## Community Consultation – Responses to Questions Received from Webinar

**To balance the input from the community and City staff, the owner is refining the project at 354 King Street West. In response to the feedback received:**

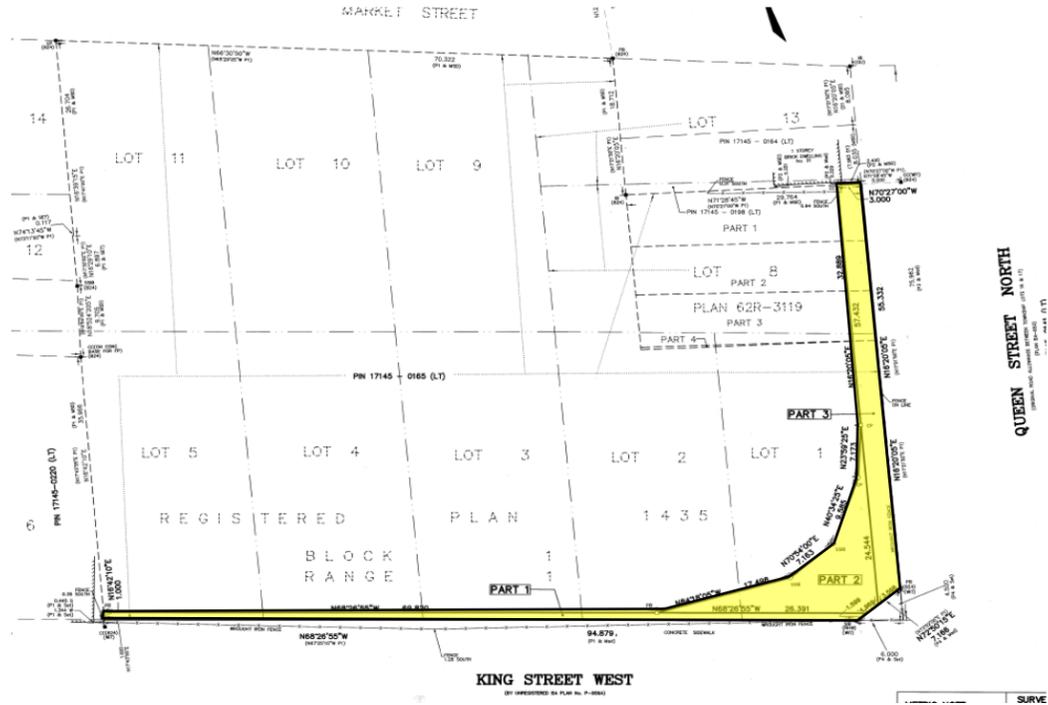
63.	Wayne MacPhail (SSD)	The approved 6-storey student residence building was a good example of an appropriate transition in height between the Downtown Zone on the east side of Queen Street and the Strathcona neighbourhood on the west side. How does the proposed increased height fulfil the requirement of Hamilton's Urban Official Plan for "transitions in height and density to adjacent existing historic residential buildings?"

Name	Question	Response
64.	Wayne MacPhail (SSD)	Could Vrancor/GSP explain how impacts of shadow, wind and density caused by the increase in height of the residence from 6 storeys to 25 storeys and hotel from 10 to 12 at 354 King, have been mitigated on adjacent lands designated Low Density Residential, as required by Hamilton's Official Plan? (in section 6.6.6.1 Mixed Use – Medium Density Designation)?	<p><b>GSP:</b> Mitigate, by definition, means to “make less severe, serious, or painful” and does not mean “eliminate” or that there will be “no impact”. The applicant has completed both Sun Shadow and Wind studies following the City’s terms of references for these studies to determine where, if any, mitigation measures are required.</p> <p><b>Shadow (SRM):</b> Section 4 of the Sun-Shadow Study Analysis (Summary and Mitigation Measures) outlines how the proposed building design mitigates shadow impacts. In summary, this includes: <i>“The orientation of this tower and step-back at Level 16 mitigate the shadow effect to the north of the site on Market Street and in turn the largest portions of the shadows cast fall to the east of the site in the downtown core where existing tall buildings currently shroud the majority of the shadow path of the proposed development. The proposed 2 storey massing along Market street to the north has minimal impact on the periphery of the site and cast shadow typical of a 2-storey dwelling with a northern facing exposure. Height has been limited on the proposed 2 storey mass to adhere to the minimum height requirements set out in the zoning by-law for this development and a flat roof has been utilized on this massing which reduces the shadowing caused by taller pitched or sloped roof systems. Located at the Southeast corner of the site the 3rd mass proposed is a 12 storey Hotel Building with maximum height of +/- 41.8 meters to the top of the highest parapet. Any shadow impact during morning hours is intercepted by the adjacent proposed 25 storey Tower to the west. Shadow impacts affecting peripheral areas outside of the proposed development are typically received after solar noon and are overshadowed by the adjacent proposed 25 storey tower.”</i> (pg. 4 of SRM's the sun shadow study analysis)</p> <p><b>Wind (RWDI):</b> The Wind Study shows that the anticipated summer and winter conditions (with the additional building height) around the lands designated low-density residential (along Ray Street and Napier) will either <i>maintain</i> current levels (comfortable for sitting, standing, and strolling) or be slightly affected (i.e. moving from comfortable sitting level to comfortable standing level). A number of mitigation measures have already been incorporated into the site design (i.e. landscaping, fencing, entrance door orientation).</p>

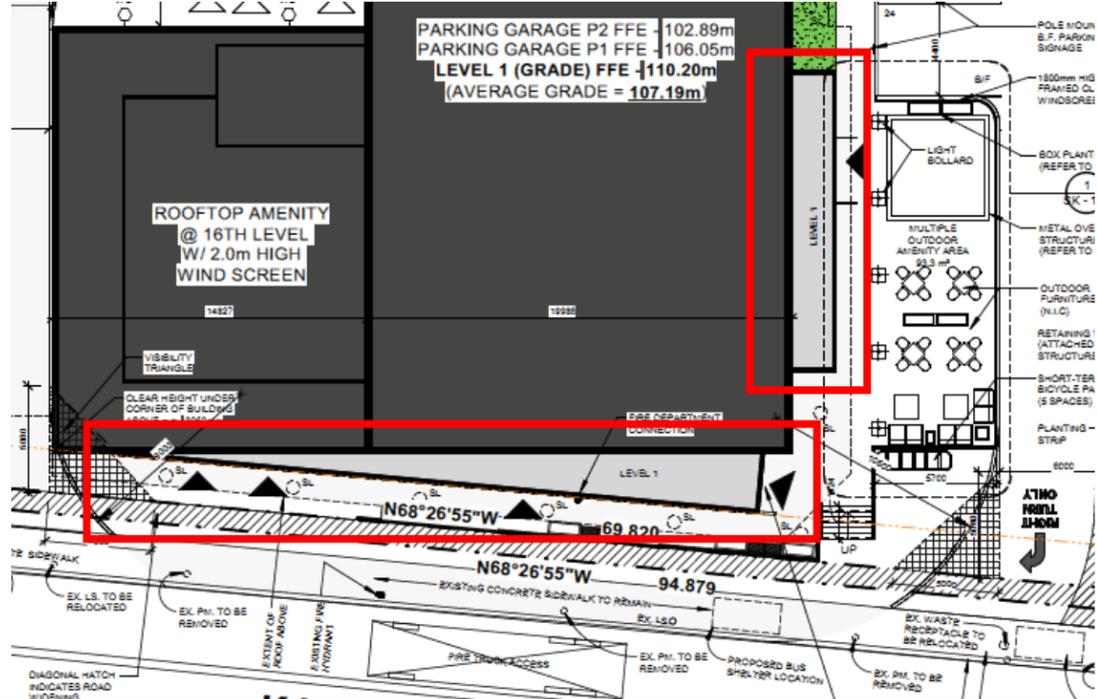
90.	Wayne MacPhail (SSD)	On slide 22 you aptly demonstrate how the tower will in fact dominate the neighbourhood vista.	<p><b>GSP:</b> This image shows that the buildings <b>will</b> be highly visible along King Street W. However, as the Visual Impact Assessment found - it will not dominate any of the City's <i>significant vistas</i> (panorama of the Niagara Escarpment or Downtown Skyline).</p> <p>The City differentiates between views and vistas. Vistas are generally panoramic in nature while views usually refer to a strong individual feature often framed by its surroundings. Examples of existing significant vistas include the</p>

Name	Question	Response
			<p>panorama of the Niagara Escarpment, Hamilton Harbour and the Downtown skyline as viewed from various vantage points throughout the City. These Vistas were analyzed in the Visual Impact Assessment.</p> <p>The buildings will be visible from local viewpoints and local streets but will not significantly impact any vistas (panorama of the Niagara Escarpment or Downtown Skyline).</p>
